TECHNICAL SERVICE BULLETIN 10046

MODEL(S): 150GTL, 200GTL

DESCRIPTION: After adjusting the squelch control, sometimes received signals may sound choppy due to the squelch repeatedly opening and closing.

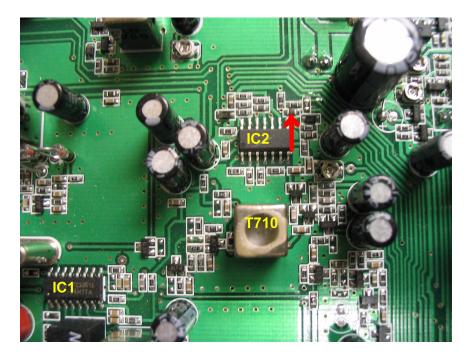
ACTION: Change R47 to a 2.2 meg-ohm resistor. This will increase the squelch hystersis.

See page 2 for the location of R47.

ADJUSTMENTS: 1. Turn the squelch control fully clockwise.

- 2. Inject a 1500µV signal to the antenna connector (1KHz, 30% modulation).
- 3. Adjust RV2 until the squelch just opens.
